4294A-05E

Information Only Service Note

4294A Precision Impedance Analyzer

Part Number Changes for LCD and LCD Assemblies with backlight lamp change recommendation

Figure1-1 Old Generation LCD Assembly

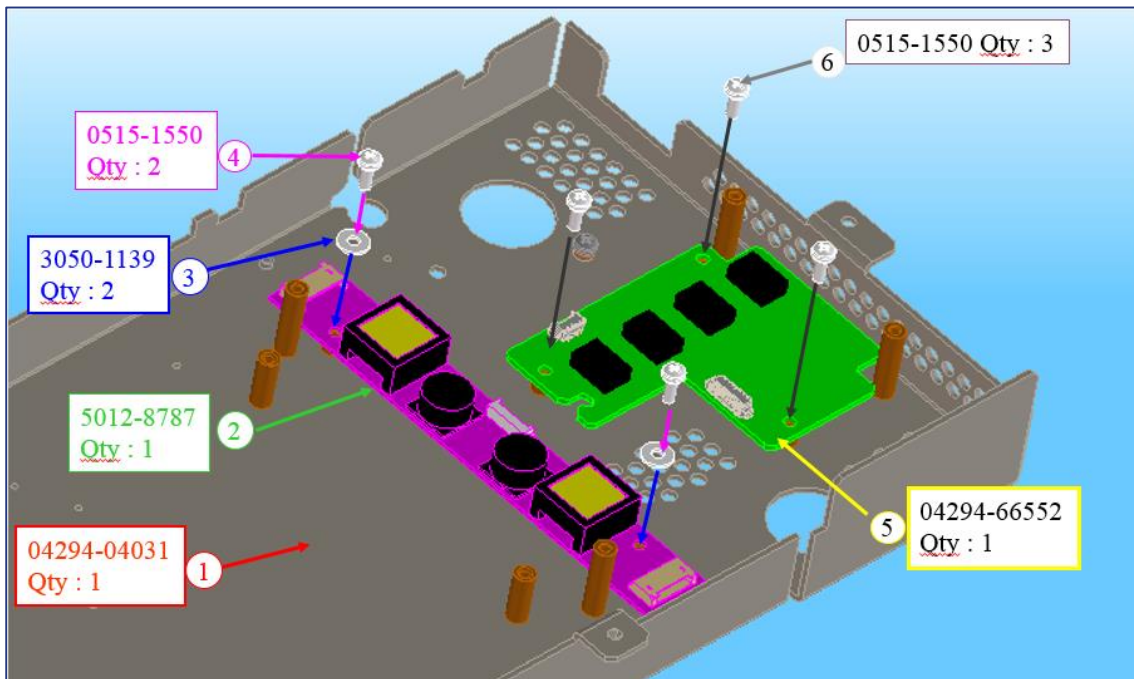
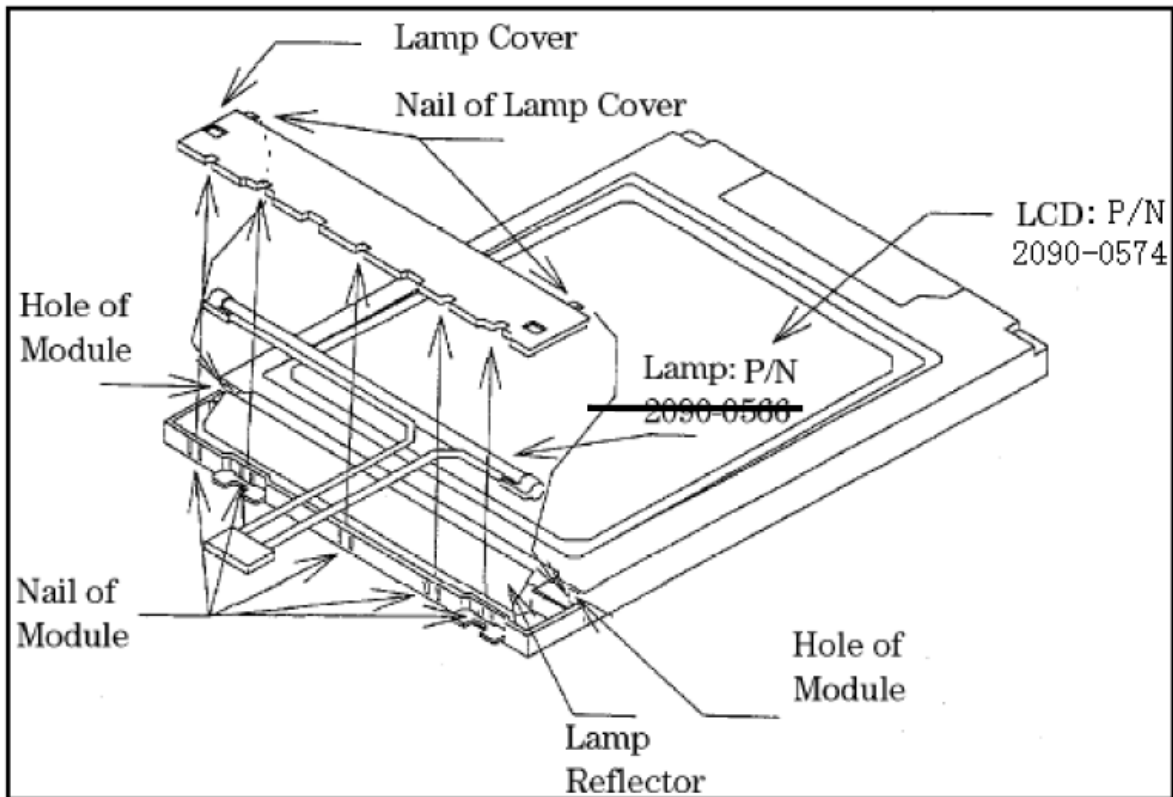
Shown is the comparison between the LCD assemblies described in Table 2-1 and Table 2-2. Note on the significant hardware design change - horizontally installed inverter (older generation JP2KG01017 to MY43202238) versus vertically installed inverter (new generation MY43202239 and above).

Serial numbers: MY43202239 and above
 Replace LCD Display assembly **04294-60102**

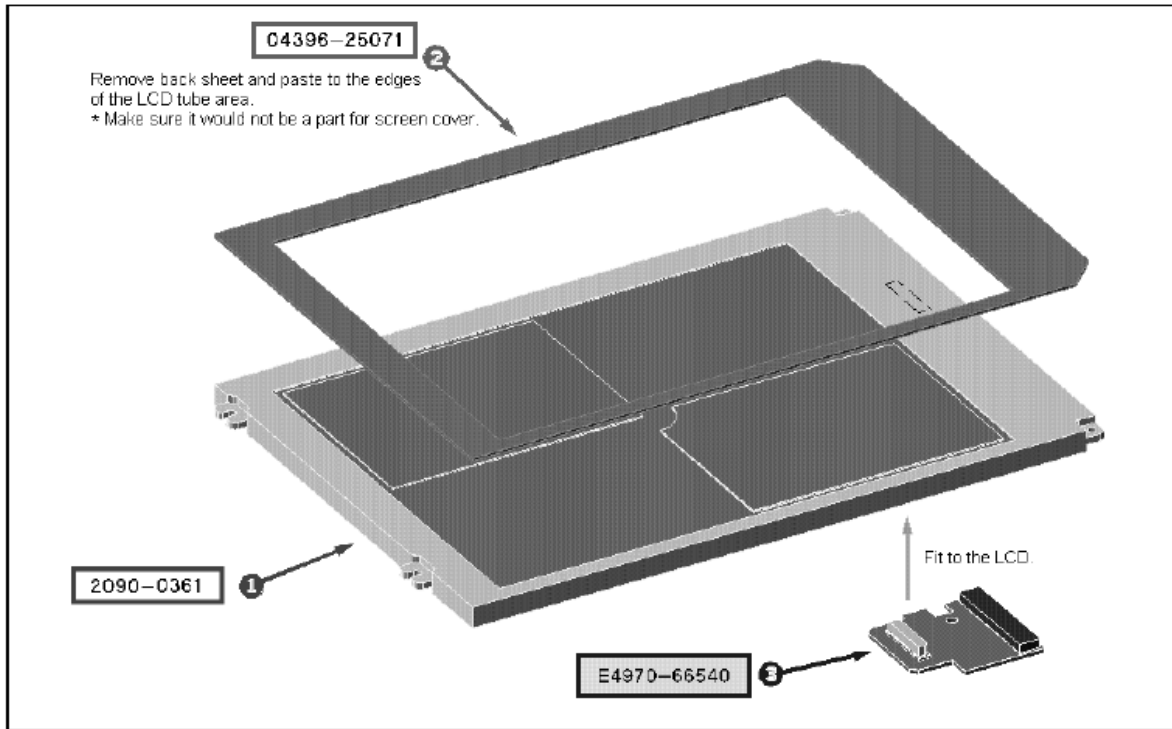
When replacing the backlight lamp in the old LCD, remove the lamp install new one as illustrated in the following figure.

2090-0556 was replaced by 5188-1640
